## ADDENDUM NO. 1 WASTEWATER SYSTEM IMPROVEMENTS CONTRACT 16-02 MILLER AVENUE WASTEWATER TREATMENT PLANT IMPROVEMENTS JACKSON ENERGY AUTHORITY JACKSON, TENNESSEE WAUFORD PROJECT NO. 3590 JEA WORK ORDER NO. 1700553 CDBG DISASTER PROJECT NO. 54299

Date of Addendum: Thursday, December 13, 2018
Mandatory Pre-Bid Conference:
Tuesday, January 8, 2019, 10:00 a.m. Local Time
Bid Opening: Thursday, January 17, 2019, 2:00 p.m. Local Time

ADDENDUM NO. 1
12/13/2018 WZM
AERATION BASIN NO. 2 PIPING
PROFILES AND DETAILS SCALE 1"=20' HOR 1"=10' VER DATE J. R. Wauford & Company, Consulting Engineers, Inc. Jackson, Tennessee (731) 668-1953 www.jrwauford.com 3590 OCT., 2018

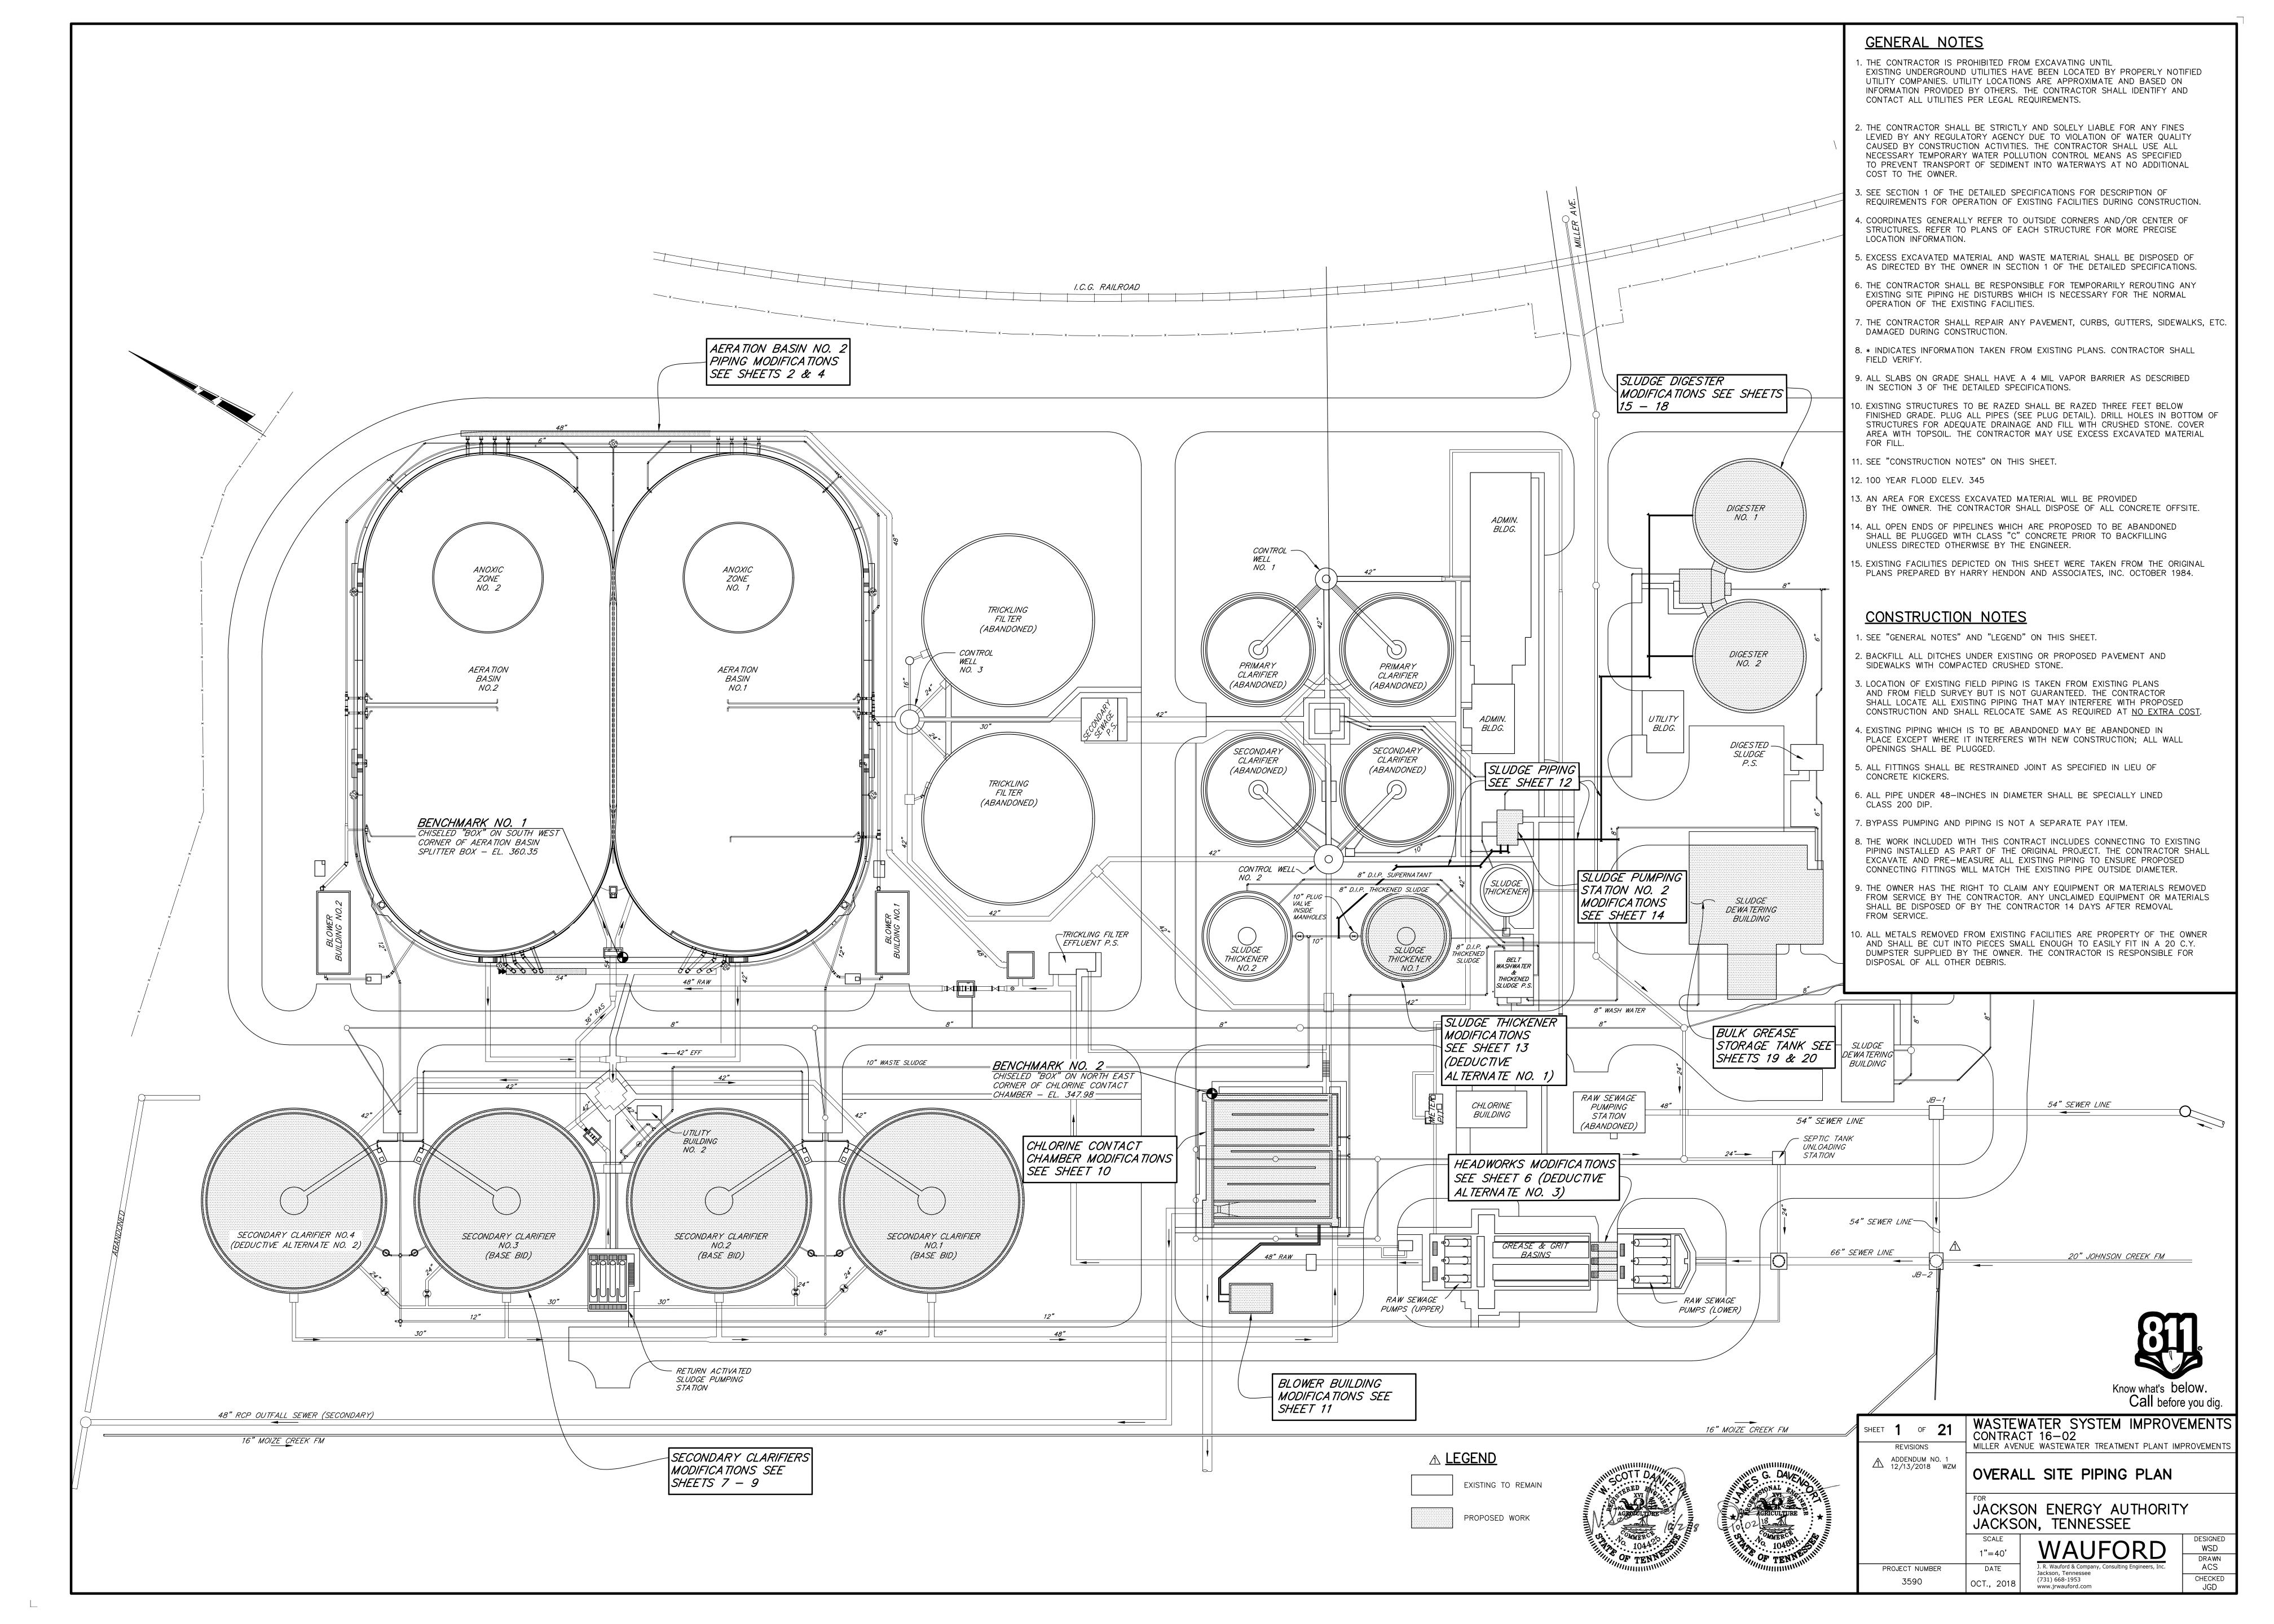
Revise as indicated on the attached Plan Sheets.
